STRATEGIC INFRASTRUCTURE DEVELOPMENT CASTLEBANNY WINDFARM

Kilkenny County Council Meeting

29th March 2021

Description of Development

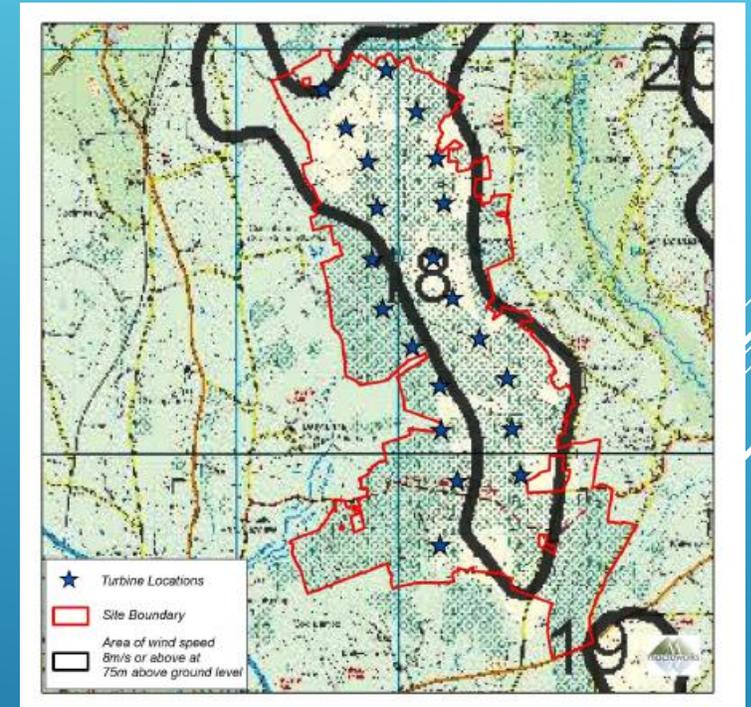
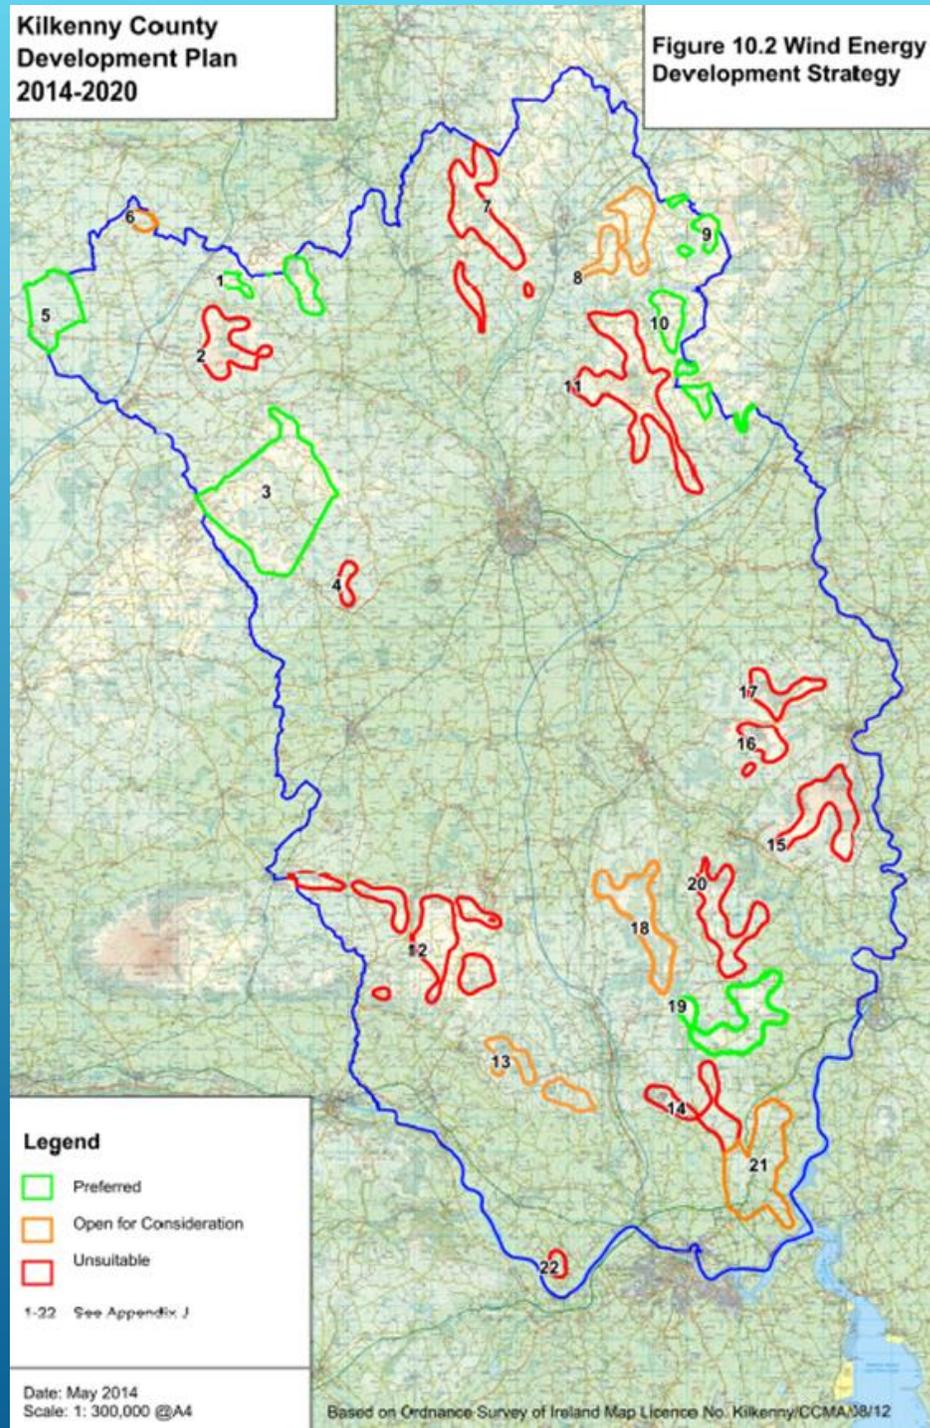
Area 18 on the map is the
area identified as Open
for Consideration

It roughly equates to the
area of the wind farm.

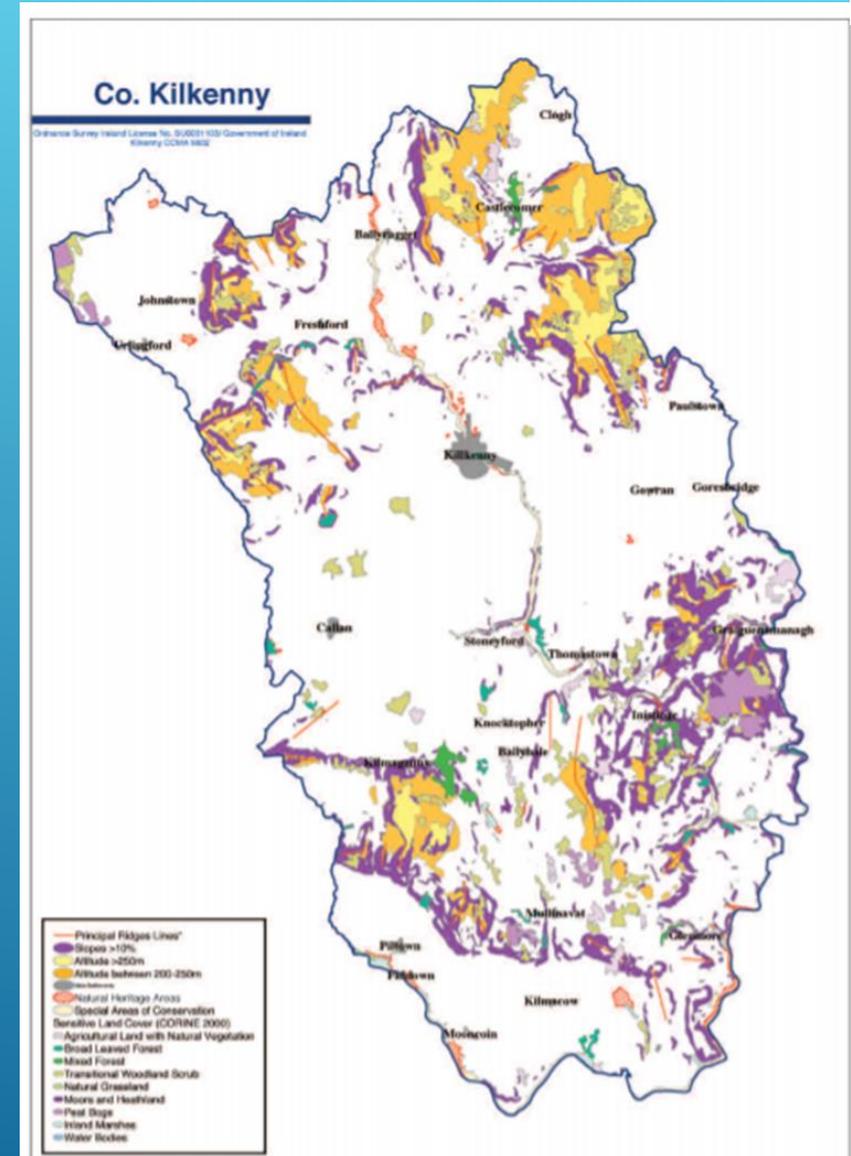
Contention of the Planning Authority that insufficient weighting has been given to the landscape sensitivity of this area in the design siting and layout of the windfarm.

Guidance in respect of 'height' of turbines is conservative, *"Turbines should relate in terms of scale to landscape elements and will therefore tend not to be tall"* (2006 WEGL)

Considered therefore the proposed development would detract from the landscape character of the area and result in a significant negative visual impact

Arrigle Valley at Colnahau townland Viewpoint Ref: VP38

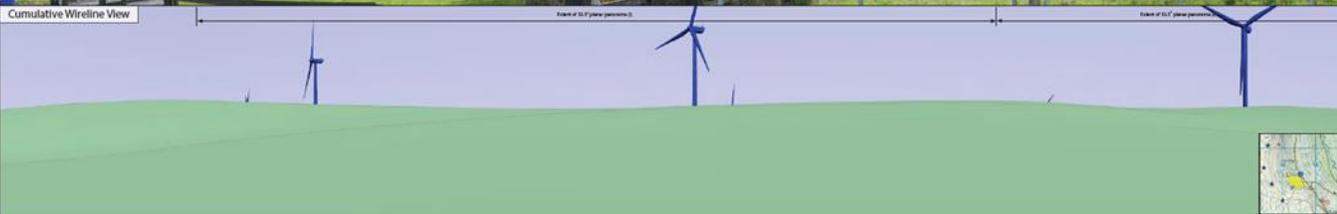
- Visual Impact Assessment provided is not sufficiently robust and should have included additional viewpoints both locally having regard to dwelling locations and also along the open areas of the route analysis.
- Some view points were chosen where local features obscure or partially obscure the development, e.g. VP10 & V38

The Council considers that the proposed layout requires to be reviewed and revised according to a more realistic impact analysis which would require :

- (a) A reduction in the number of turbines
- (b) A greater set back from sensitive receptors .. and/or
- (c) A reduction in the overall height of the turbines.

St. Molin's Well

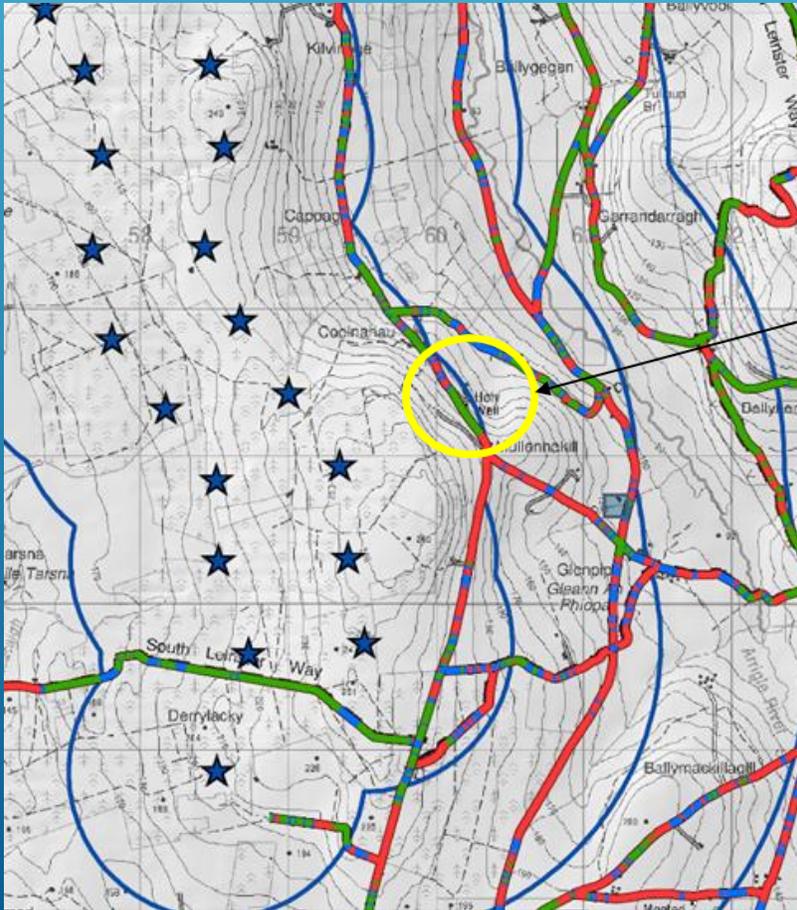
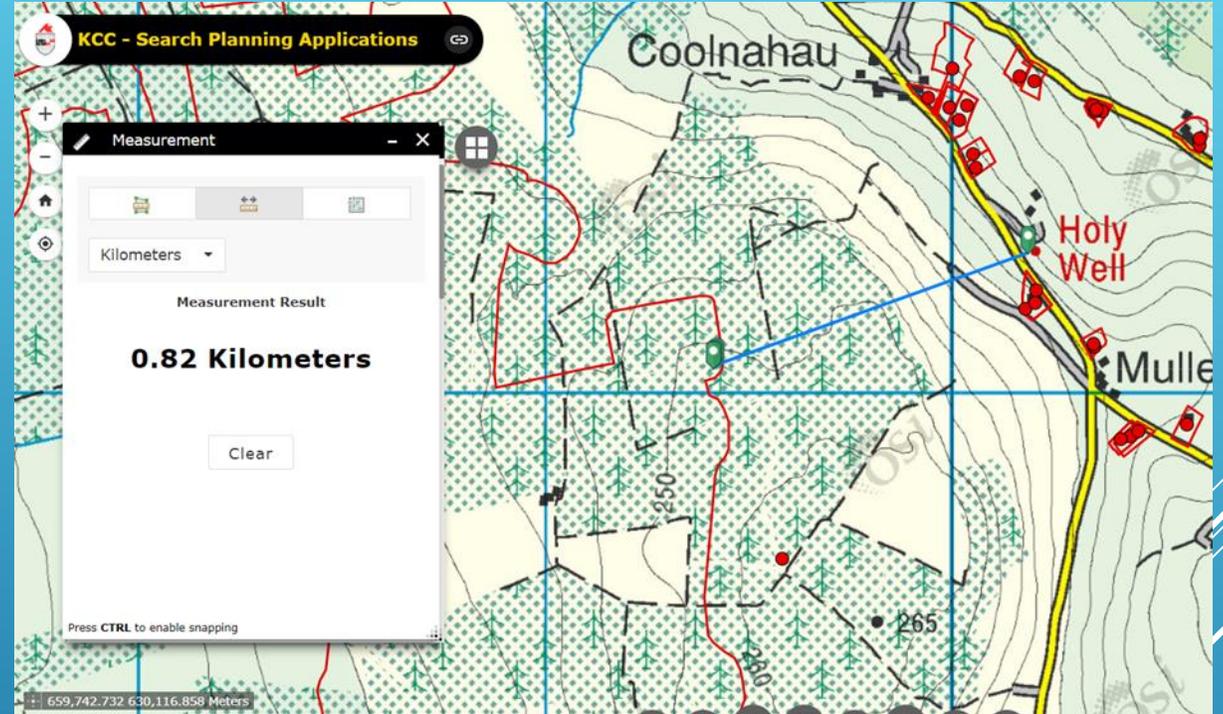
The Council considers the assessment of impacts of the proposed development on St Molin's well is weak.

The well is located directly east of the proposed windfarm across the Arrigle River Valley.

It is of the order of 800m as the crow flies from the nearest turbine.

St. Molin's Well is within a location along the public road which is identified as having an open view to the site.

The Council would consider that given the proximity of the site to the development and the clear views from the Holy Well across the river valley that the potential impact here needs to be examined in more detail and mitigation measures to be introduced.
